UNITED STATES PATENT AND TRADEMARK OFFICE

Office Action Summary

Application No.
10/083,079

Fig.3

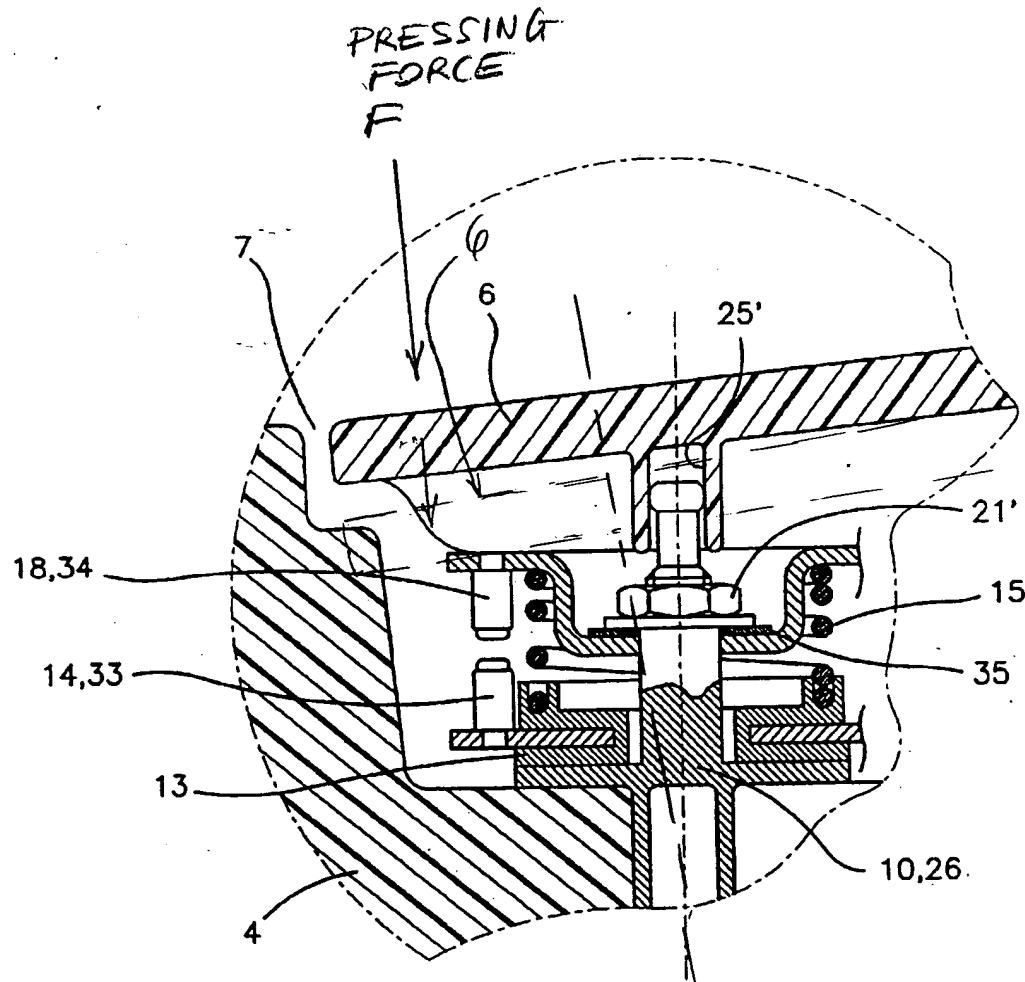
movable/displaceable and parallel to the axis for actuating Bohn's horn contacts 14 and 18 (Fig. 3). When a driver presses or pushes Bohn's cover cap 6 down, Bohn's cap 6 is moved downwardly, consequently, Bohn's guides 10 or 10,26 is moved downwardly to make Bohn's switch 18 in contact with Bohn's switch 14 to actuate the horn as shown in Bohn's Fig. 3. Since Bohn's casing 6 is made of foam, thus, it is flexible and since Bohn's casing 6 and guides 10,26 are integrally connected together as transparently shown in Fig. 3, thus, if the driver applies his/her pressing force F (see Attachment) at a region of the outer edge of Bohn's casing 6, the casing 6 is inherently flexed or tilted downwardly, hence, the guide 10,26 is tilted therewith. In summary, Bohn implicitly discloses applicant's claimed functional language.

As seen in the above quoted argument, applicant expressly admits that Bohn's mounting plate 30 and mounting tab 17 may be tilted to actuate the horn switch 18, 14 as seen in Fig. 3. However, applicant concludes that the clearance space created by through hole 20 between the mounting tab 17 and the mounting stud 10 precludes any transfer of movement from the tab 17 to the stud 10. This assertion overlooks the fact that the upper part of the stud 10 is located within the guide recess 25' of the casing 6. Since the movement of the casing 6 is transmitted to the stud 10 via the guides 25', the stud 10 of Bohn is tilted when the casing 6 is tilted during actuation of the horn switch. In

addition, applicant's arguments that "even if a large force is applied to the cover cap of Bohn et al., the bolts 10 will not inherently tilt" is apparently in direct conflict with applicant's own admission that **"the bolts will tilt"** in the above quotation. Contrary to applicant's inconsistent arguments, if a large force is applied to the cover cap of Bohn et al., the bolts 10 will inherently tilt since virtually any thing will be tilted, displaced, or collapsed if enough force or pressure is applied to it. See *Fredman v. Harris-Hub Co., Inc.*, *supra*. In this case, *Webster's II New Riverside University Dictionary* defines: "tilt: to forge with a tilt hammer." If one uses a tilt hammer to hit on Bohn's casing 6 in the direction F shown in the Attachment, the stud 10 inherently is tilted or displaced based on ordinary and customary meaning of the term.
